16 December 2019

David Waldren Vicinity Centres Office Tower One/1341 Dandenong Road Chadstone VIC 3148

Re: Master Plan and Preliminary Plan feedback regarding planning and development of the Bankstown Central site

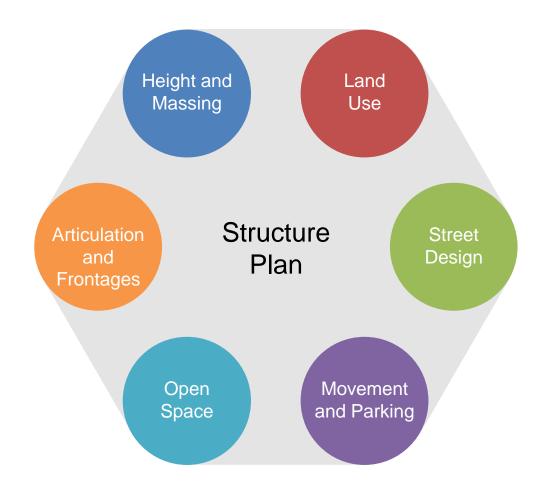
The distribution of land uses should also consider the potential impacts of residential development on a 'night time cluster' illustrated in the Bankstown CBD and Bankstown Airport Place Strategy (refer to extracted image below).

Land Use

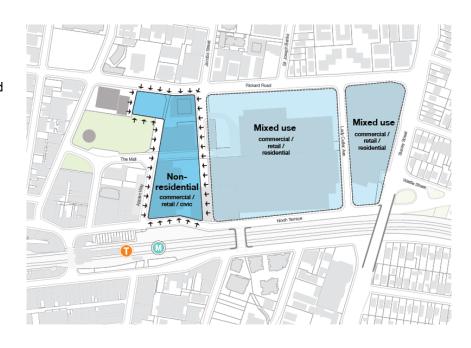
- Reinforce Bankstown CBD as a Strategic Health and Education Precinct and assist in achieving employment targets.
- Reinforce Bankstown Central as a sub-regional shopping and leisure destination and support a night time economy.
- Concentrate commercial floorspace into commercial towers around the station for larger tenants rather than dispersed across site.
- Discourage residential development in the blocks closest to the station and between Jacobs Street and Appian Way.
- Residential land use <60% of total site GFA.
- Consider >5% affordable housing.
- Any increase in residential density is to be supported with additional open space and community infrastructure.

Movement

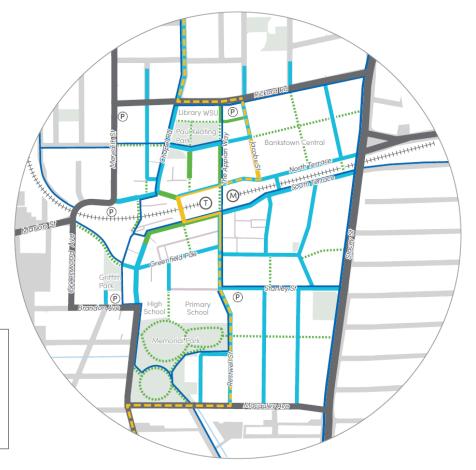
- To be consistent with the Bankstown Complete Streets Plan
- Prioritise pedestrian movement in the CBD, followed by cyclists and public transport
- Vehicles and servicing primarily accessed from edges and discouraged from travelling through the CBD.
- All streets should be designed as equitable and safe spaces with high pedestrian amenity

New Streets

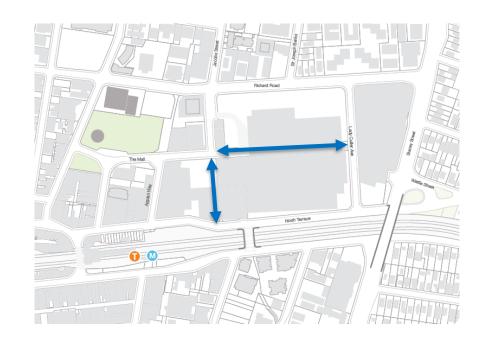
- Pedestrian prioritised/ limited vehicular access
- Min 20m wide
- · Open to sky
- Dedicated to Council or public right-of-way

- Key bus route
- Min 20m wide
- · Dedicated to Council.

Pedestrians

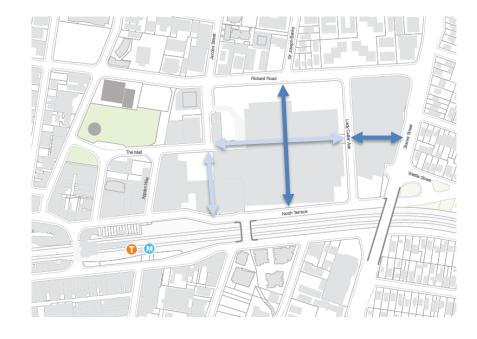
- New public pedestrian connection from Rickard Road to North Terrace.
- New public pedestrian connection from the The Mall to Stacey Street (incorporates change in levels)

Cyclists

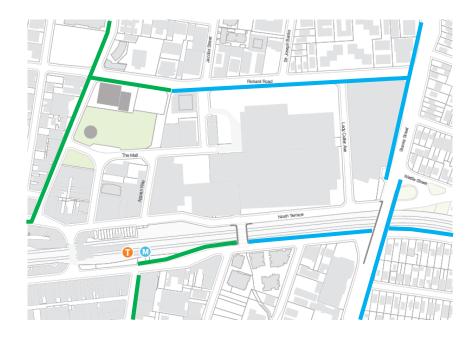
- Setbacks to Rickard Road and Stacey St for shared path.
- Provide secure bike parking and end of trip facilities for visitors, staff and residents

Public Transport

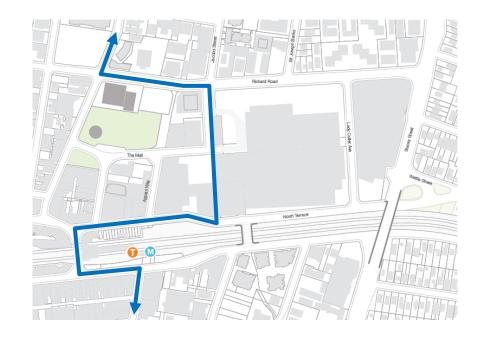
- Bus services should avoid The Appian Way and use Jacobs Street instead.
- Access to public transport facilities should be at street level.
 Pedestrian bridges and tunnels are discouraged.
- Bus layover should be located away from high pedestrian activity areas.
- Short and long term bus planning to be agreed as part of Stage 1.

Car parking and Servicing

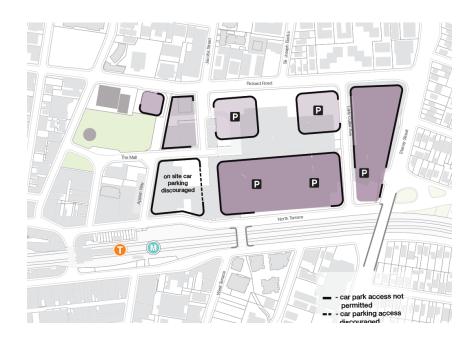
- No minimum car parking requirements for all land uses within 400m of the station and potential parking maximums.
- Reduced car parking requirements for all land uses within 800m of the station.
- Car parking and loading access limited to Stacey St, North Tce and Lady Cutler Ave to discourage traffic through the CBD.
- All parking in basements. Combine basements to limit the number of street entries required.
- Any above-ground parking to be sleeved with development (no direct frontage to streets/ public spaces) and designed to be re-purposed at a later date.
- Cater for ride hailing, AVs and electric charging infrastructure on streets and basements

Open Space

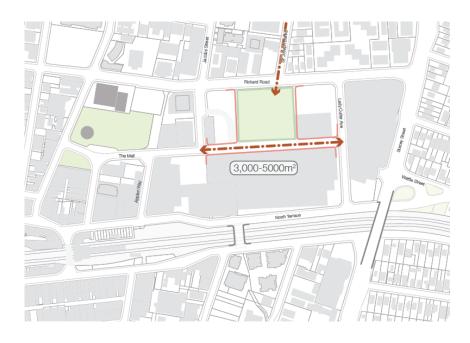
- 3,000 5,000sqm on Rickard Road
- Turf, soft landscaping, tree planting and Tier 1 playground
- Unencumbered by infrastructure (including easements and basement car parking) and drainage infrastructure
- Dedicated to Council in the first stage of development.
- At least 50% of a consolidated portion receives more than 4 hours of direct sunlight between 10am - 3pm on 21June
- Provide an urban plaza adjoining park/ east-west link suitable for events, managed by Vicinity.

Public Domain

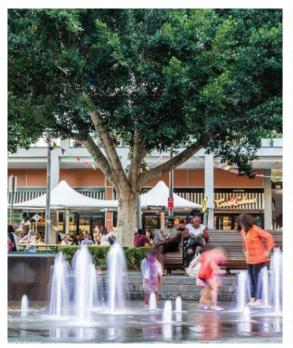
- Generous street trees and soft landscaping to ameliorate the impacts of the urban heat island affect and climate change.
- Existing mature trees of significance to be retained as far as possible
- Deep soil zones provided on each development block in communal open space areas
- Encourage the celebration of water through the CBD through the potential daylighting of buried creeks, rain gardens, WSUD and use of water features.

Building Height

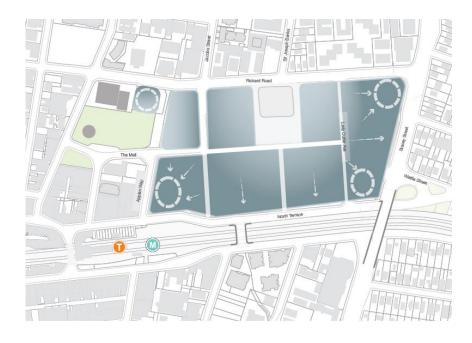
- Greatest heights located near the station, North Terrace and Stacey Street with landmark buildings on corner sites as identified.
- No change to existing heights on Rickard Road (35m).
- Requirements for wind modelling and amelioration measures to prevent wind down drafts into the streets, public open spaces and communal areas.

Street Wall

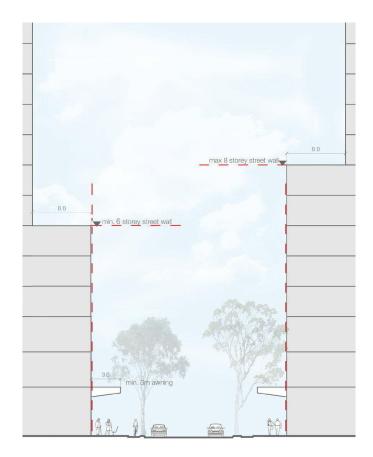
- Street wall around Paul Keating Park and The Appian Way to match the parapet height of the existing Library (approx. 4 storeys)
- Street wall to Rickard Road 4 6 storeys
- Street walls in the remainder of the site 6 8 storeys
- Buildings above the street wall to be set back 8m

Building Articulation

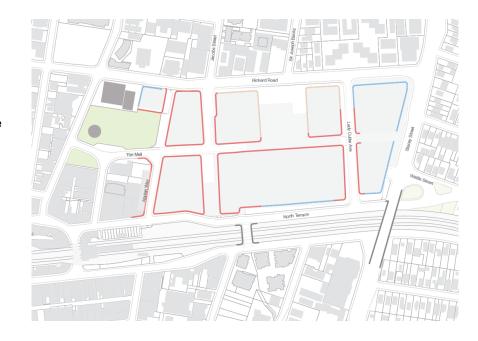
- 36m building separation for residential buildings over 12 storeys to improve access to sky and solar amenity.
- 20m building separation for commercial buildings over 12 storeys to preserve views to sky from the public domain and regional views across and through the centre.
- Buildings to be articulated to create a composition of individual buildings rather than large blocks.

- No building above the street wall more than 45m in length
- Buildings longer than 30m to be articulated with recesses and setbacks.
- Residential towers maximum GFA floorplate of 900m2
- Commercial towers maximum GFA floorplate of 1,200m2
